Re: 3020 43rd Street, N.W.
BZA Appeal No. _____
BZA Application No. 16521

BZA
Case No. 16521
Exhibit No. 41

EXHIBIT
A
PENGAD-Bayonne, N. J.

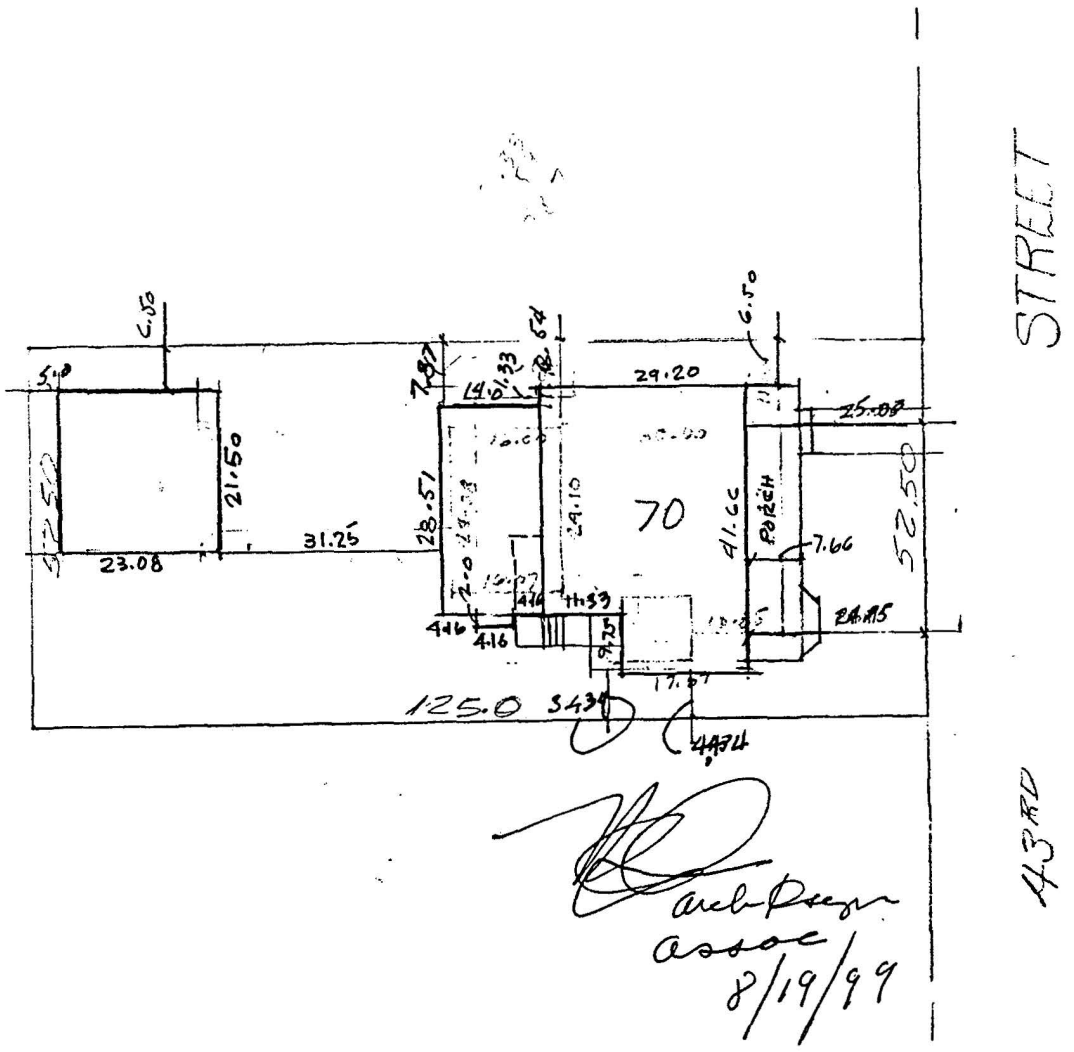
b. The Applicant's current Surveyor's Plat (Exhibit A) shows a north side yard of 6.50 feet, a south side yard of 4.434 feet, and a building width of 41.66 feet. The sum of the two (2) side yards and the existing building exceeds the established 52.50 foot lot width of the property.

EXHIBIT
D

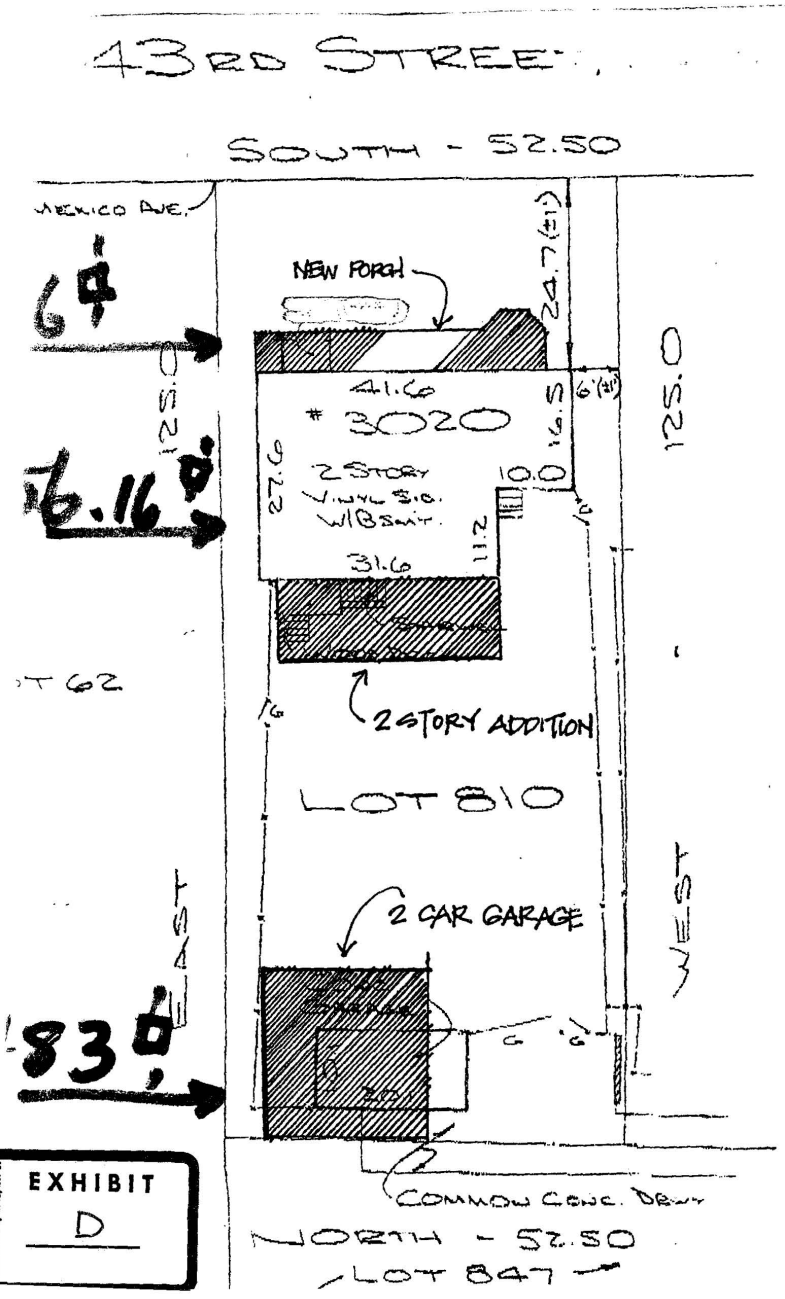
a. The Applicant's original building permit application in January 1998 (Exhibit D) showed a south side yard of "6' (+/- 1')," a house width of 41.6 feet, and no dimension on the north side yard (adjacent to Mrs. Crary). Based on the information provided, the north side yard was 4.9 feet, but could have been 3.9 feet. The minimum side yard allowed for an addition under 11 DCMR 405.8 is 5.0 feet. The north side yard for the illegally constructed improvements is less than the minimum 8.0 feet required. This is an additional violation of the Zoning Regulations.

c. Field measurements conducted by the undersigned and an ANC 3D Commissioner based on Surveyor's markers in the ground and the illegally constructed improvements, show a north side yard of approximately 4.50 feet. This measurement agrees with anecdotal information provided by the prior and long-standing owner of the subject property and Mrs. Crary and the Applicant's own documentation in Exhibit D.
